FORM P3: ADMINISTRATIVE DECISIONS AND MINOR AMENDMENTS

Re: Minor Amendment to Site Plan - Justification Letter-PR-2019-003077

This letter is intended to provide you with a justification for the changes which have occurred on the Element hotel project Permit# BP-2021-31134. We request your approval for the minor modifications to the approved DRB plan outlined in detail below.

Site Plan

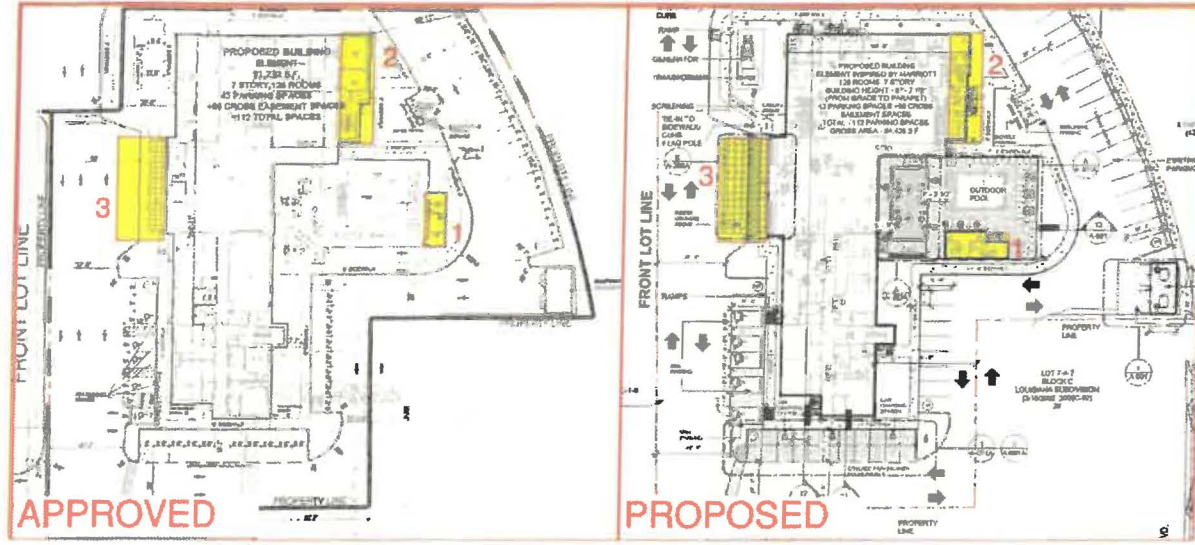
- The outdoor pool bathrooms, mechanical room and storage were relocated to meet requirements from the Marriott franchise.
- The drop off canopy was added with additional supports for the cantilever and the vestibule was slightly extended out to accommodate requirements from the Marriott franchise.

East Elevation

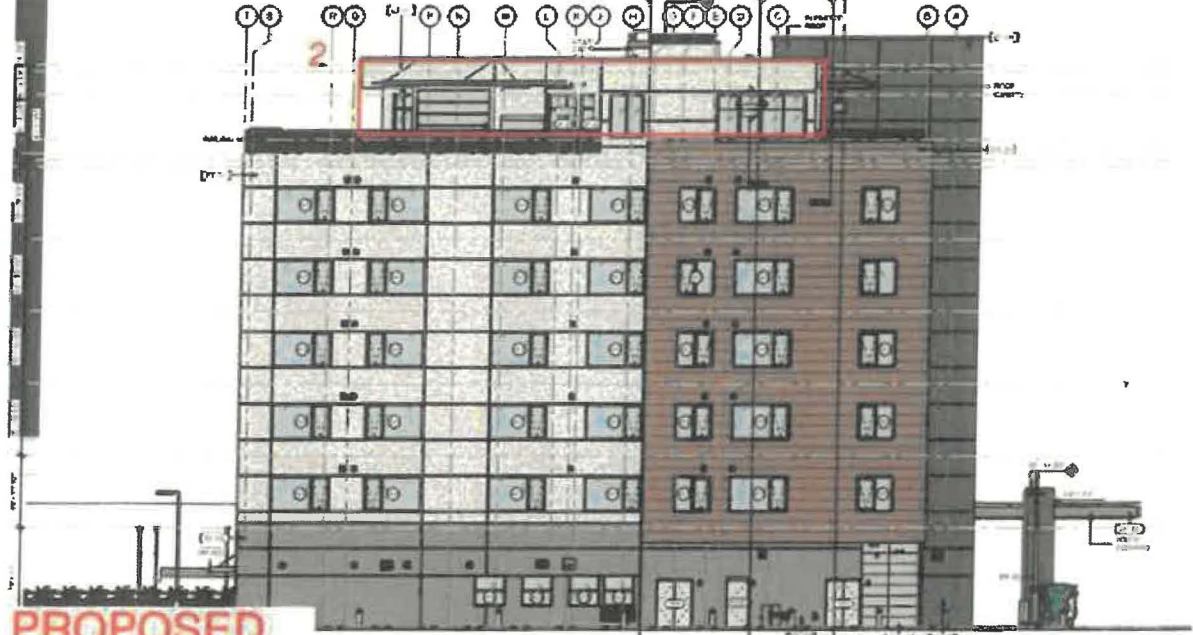
- The base material was upgraded, wooden fiber cement panels to replace EIFS and the color of the volume in the background on the right-hand side was changed from a light color to a dark. These were done to meet requirements from the Marriott franchise.

- The exterior glazing was added to meet requirements from the Marriott franchise.
- On the 7th floor rooftop bar, there was a reduction in outdoor space to provide back of house support and two public restrooms, per the City's requirements. The square footage change was approximately 2% to the total square footage.

GENERAL NOTES - SITE PLAN

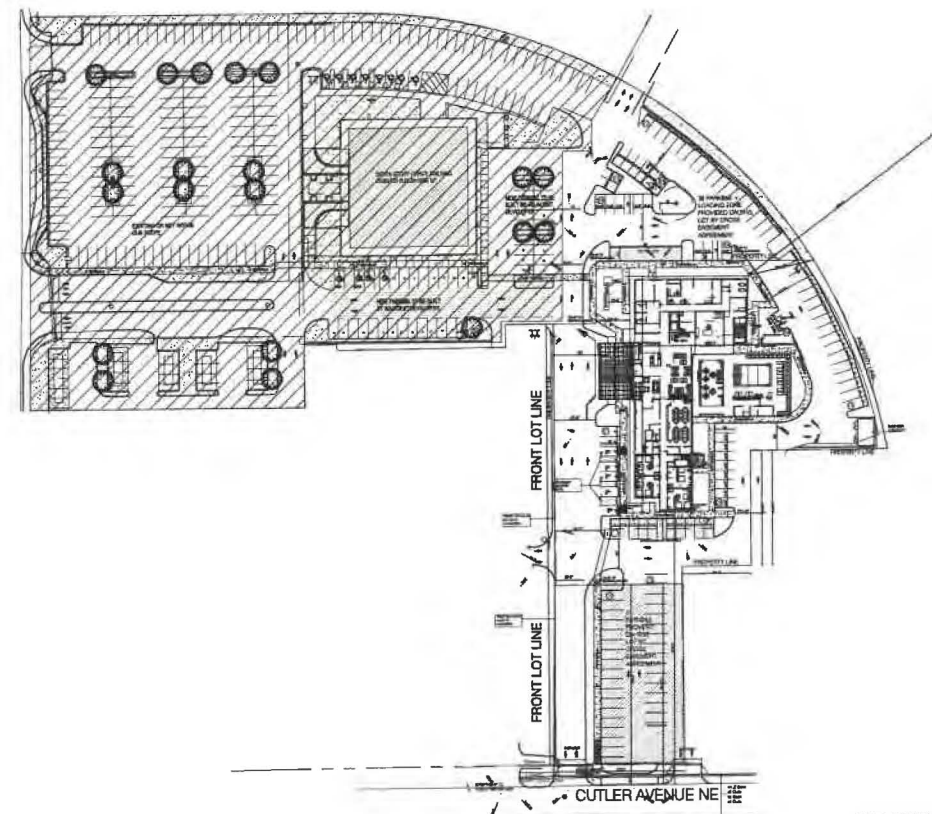
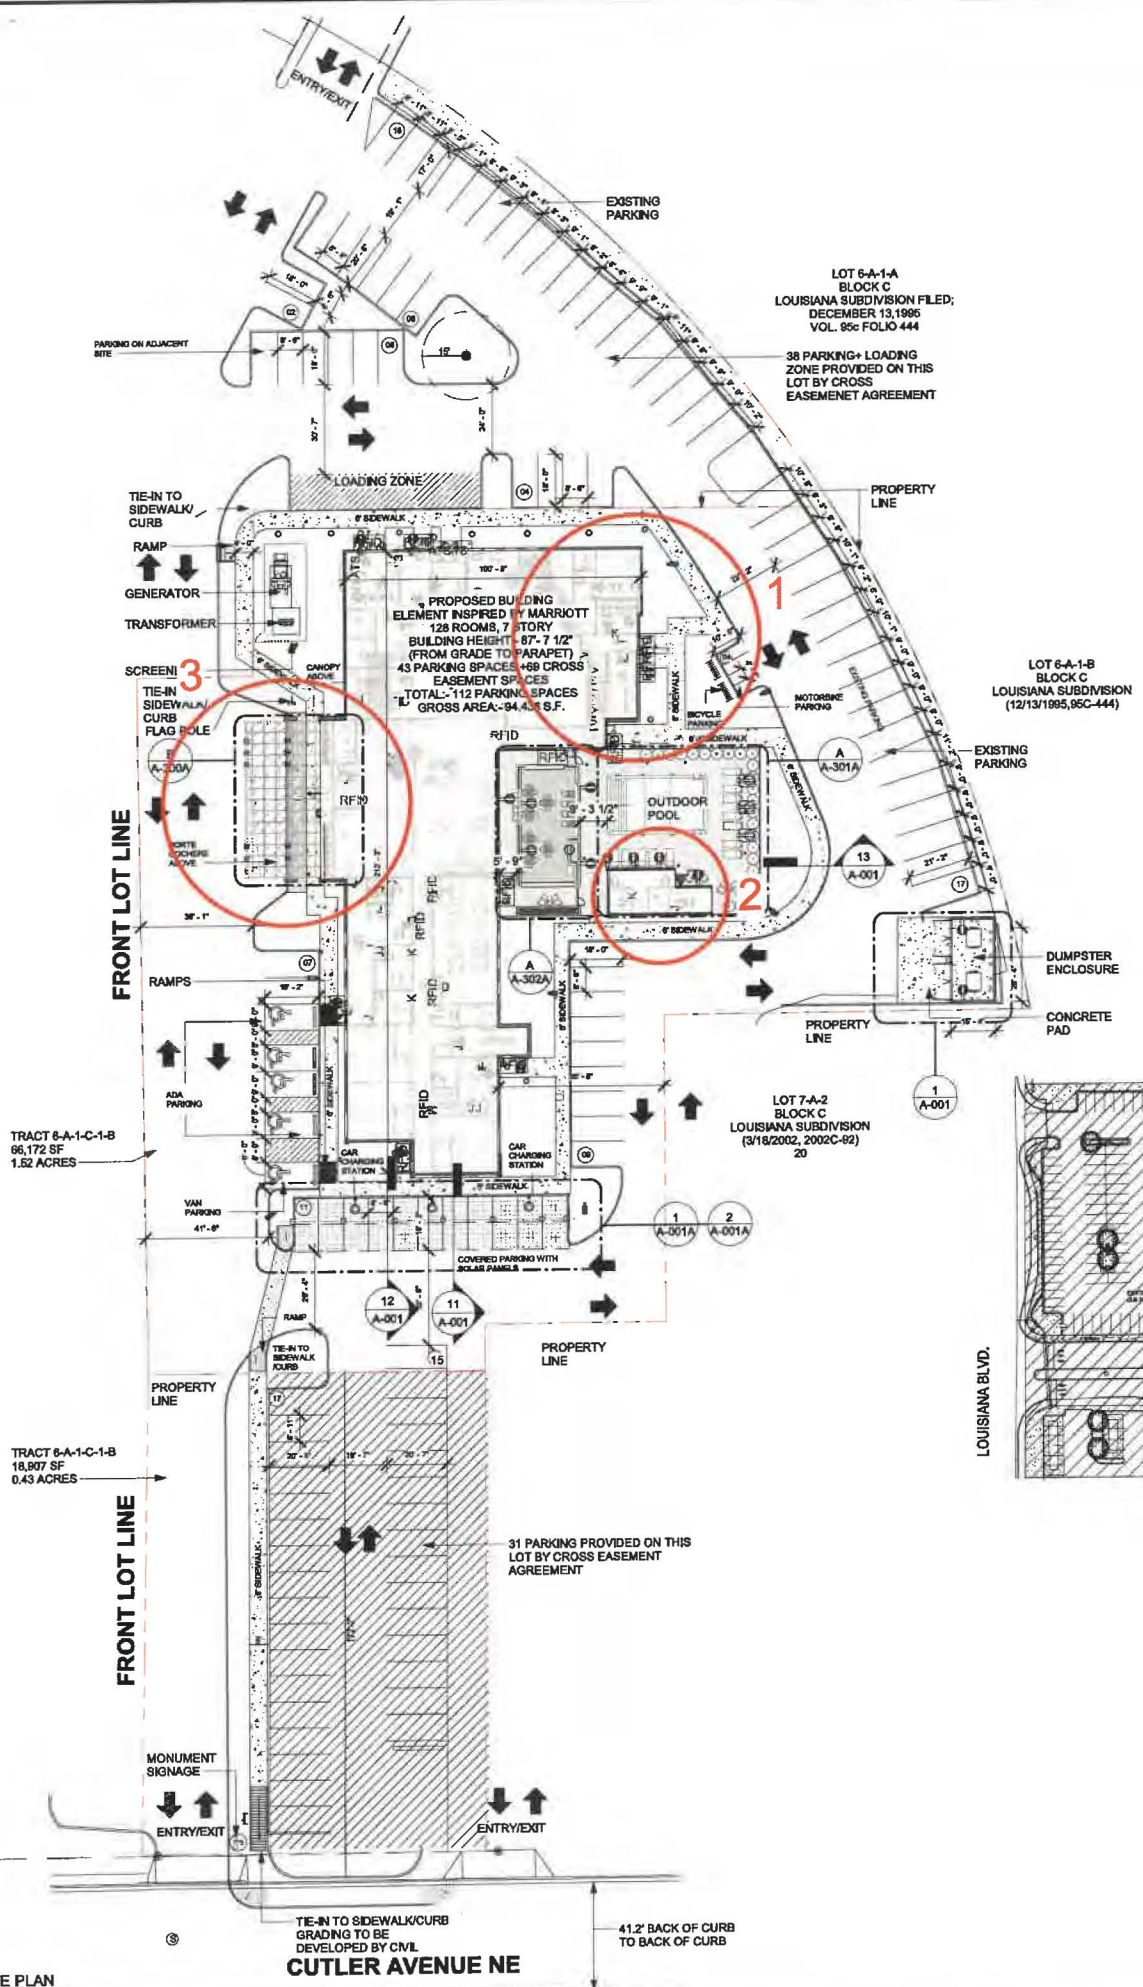
2. The outdoor pool bathroom, shower and mechanical room have been relocated in order to provide more circulation around the pool.

3. The porte cochere canopy has been included to protect guests from the elements at the drop off.

MASTER SITE PLAN

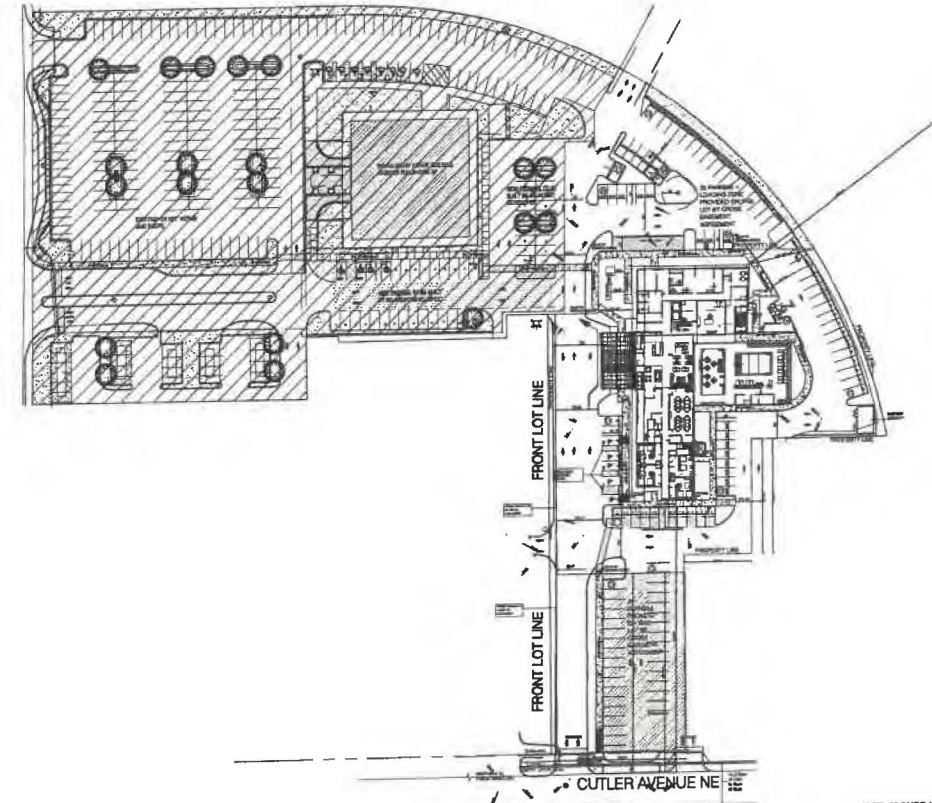
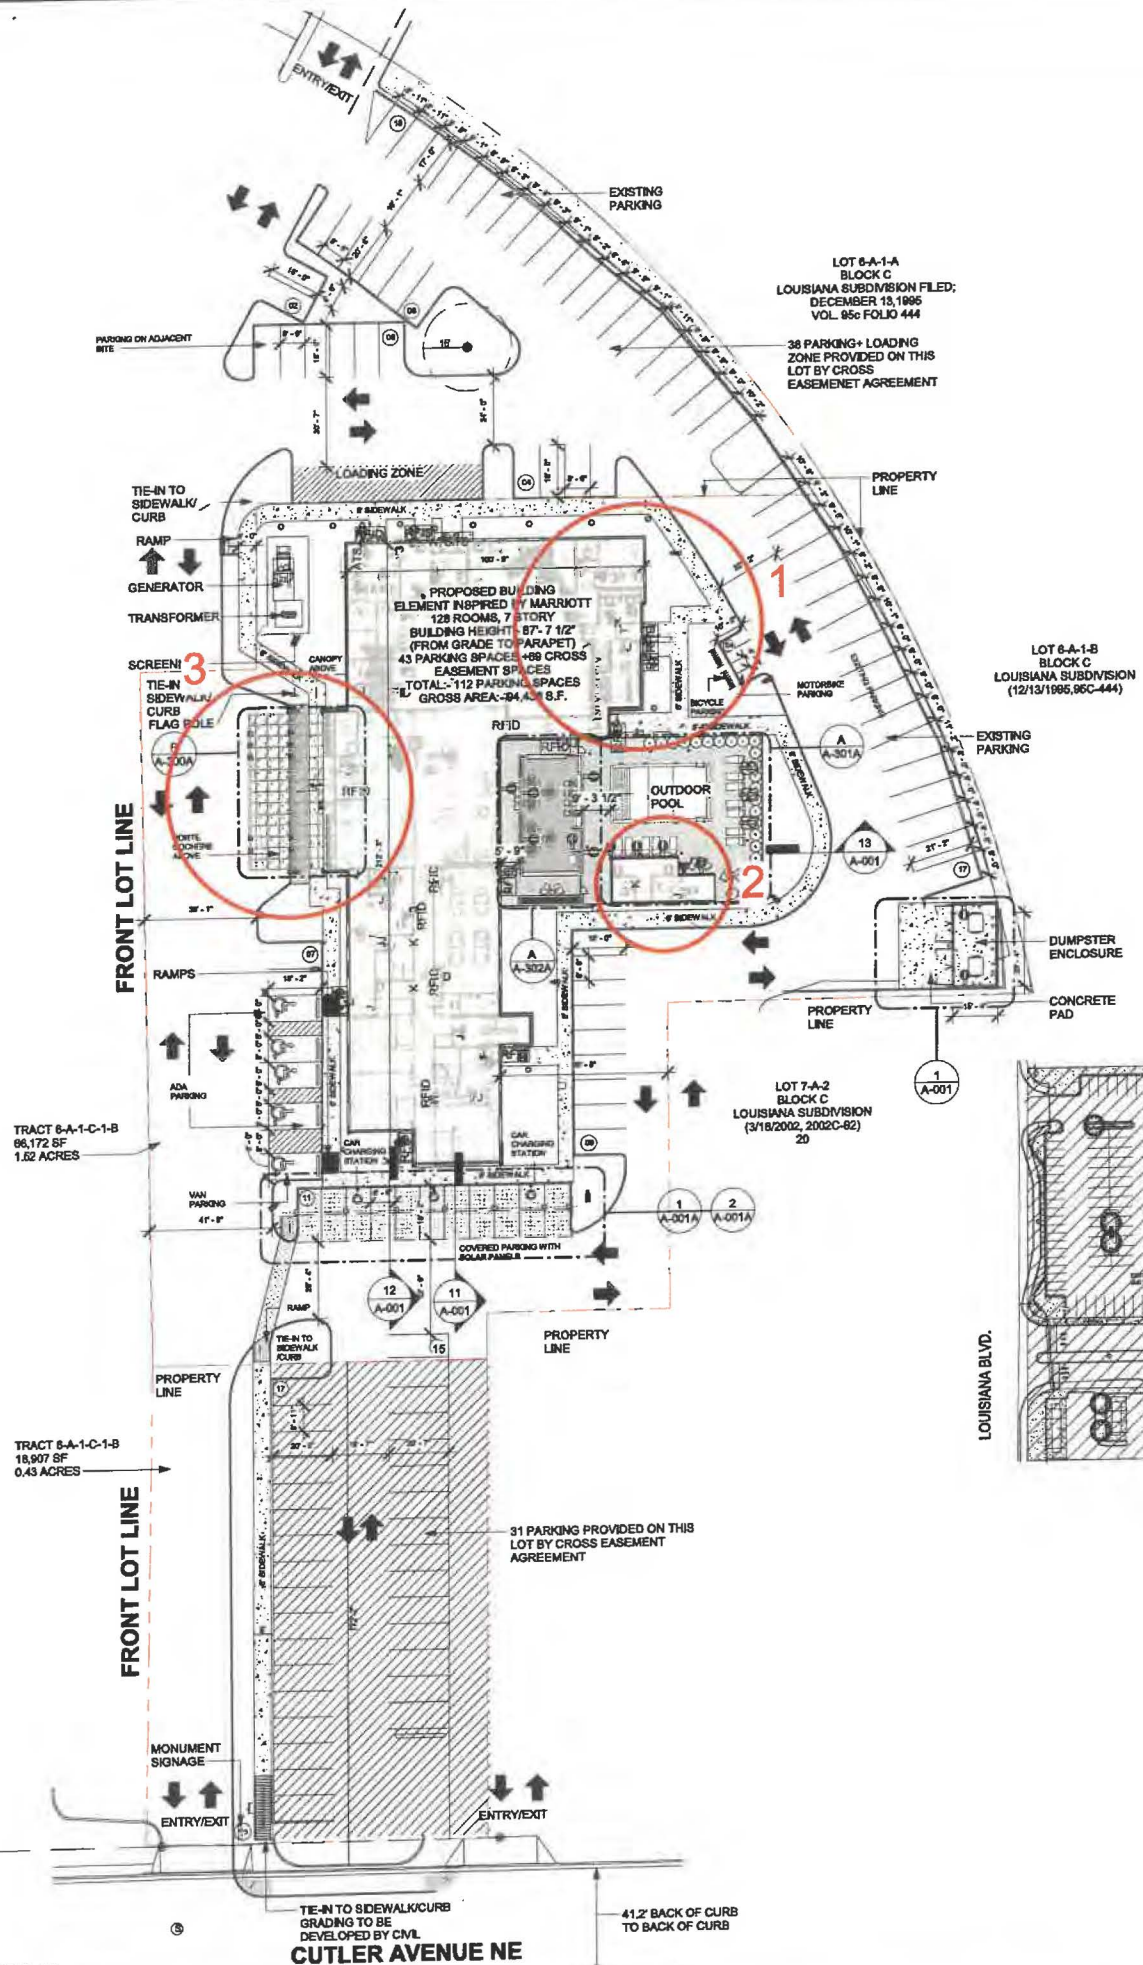
2. The outdoor pool bathroom, shower and mechanical room have been relocated in order to provide more circulation around the pool.

3. The porte cochere canopy has been included to protect guests from the elements at the drop off.
